U S NAVY RESPONSE TO U S EPA REGION III COMMENTS TO DRAFT SAMPLING AND
ANALYSIS PLAN SITE 7 EXPANDED REMEDIAL INVESTIGATION NWS YORKTOWN VA
2/9/2012
CH2M HILL

Subject: Response to Comments
Draft Sampling and Analysis Plan, Site 7 Expanded Remedial Investigation
NWS Yorktown
Yorktown, Virginia

Figure 1
Site 7 Proposed Soil Sample Locations
Naval Weapons Station Yorktown
Yorktown, Virginia

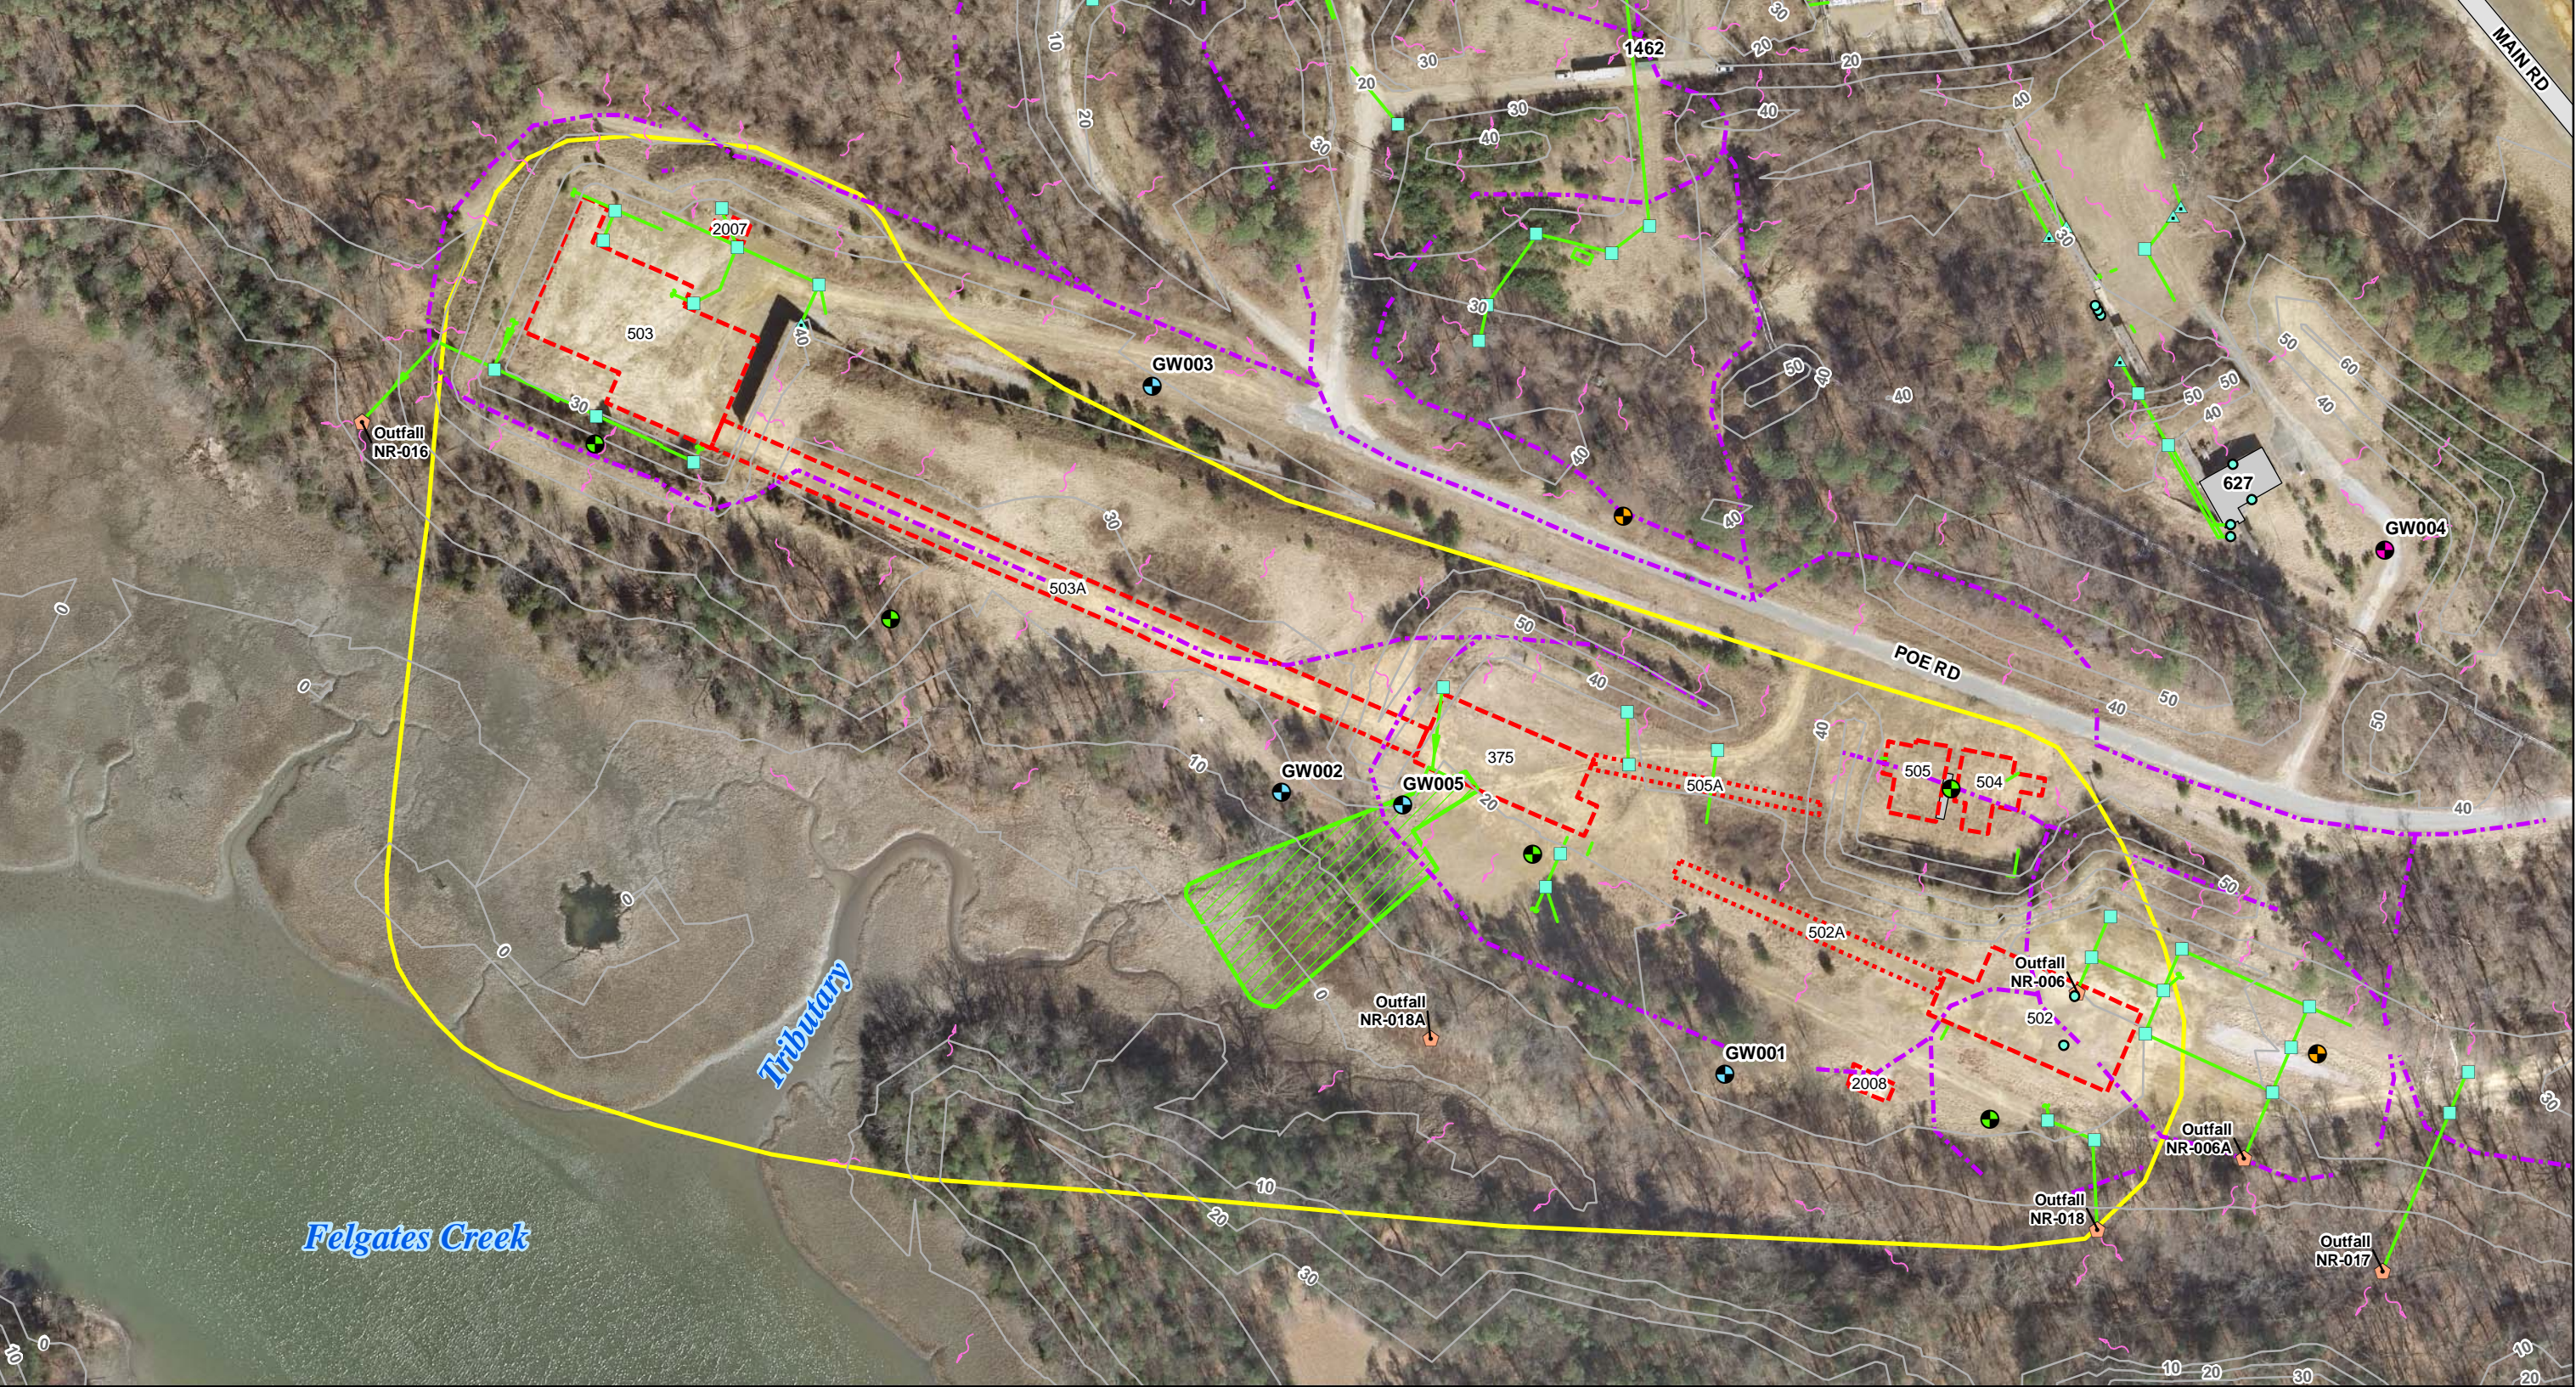
1. Page 6: The executive summary notes in the first bullet that eight primary co-located surface and subsurface soil samples will be collected. This number of samples appears too limited. Figure 2 shows seven numbered buildings and three conveyer buildings. Building 375 appears to be more than one building. There is a single soil sample location associated with each of these buildings/conveyers. At a minimum, composite sampling should be considered at smaller buildings, and one sub-sample per 2,500 square feet at larger buildings at the site. In addition, it is not clear if all the soil/sediment within the study area boundary has been adequately sampled.

11. Page 42: The text indicates that the area between and downgradient of buildings 502 and 503, as well as the area in the vicinity of buildings 504 and 505, would require additional evaluation. It is assumed that this additional evaluation will involve sampling/analyses for contaminants. What is not clear from this report is whether, or not, there are other areas within the study area boundary that will need additional evaluation. It is important that the previous sampling activities are adequately so the basis of the current sampling design can be understood.

To address the EPA's concern regarding the number of soil samples, the Navy will no longer collect primary and secondary samples and agrees to increase the number of soil sample locations in the UFP-SAP from 11 locations (including two upgradient) to 28 (including two upgradient), which will include both discrete surface and subsurface samples (resulting in an increase from a total of 22 soil samples to a total of 56 soil samples). The soil sample locations are provided on the attached Figure 1 and were developed through a review of building drawings, site topography, and storm water drainage maps. The rationale for each soil sample

location is provided in attached Table 1 and will be included in the draft final UFP-SAP, but are located in positions which will best determine locations of potential releases and contaminant accumulation. The collection of these discrete samples will also provide sufficient data to conduct screening risk assessments.

Response: Please see the Response to Comment 1, the revised proposed sampling Figure 1 and Figure 2, and attached Table 1, which present the location and rationale for additional discrete soil samples and monitoring well stations across the Plant 3 environ (including Buildings 502, 503, 504, and 505). New soil and groundwater data will be evaluated from these areas and a determination made as to whether sediment, surface water, pore water or seep samples will be collected.
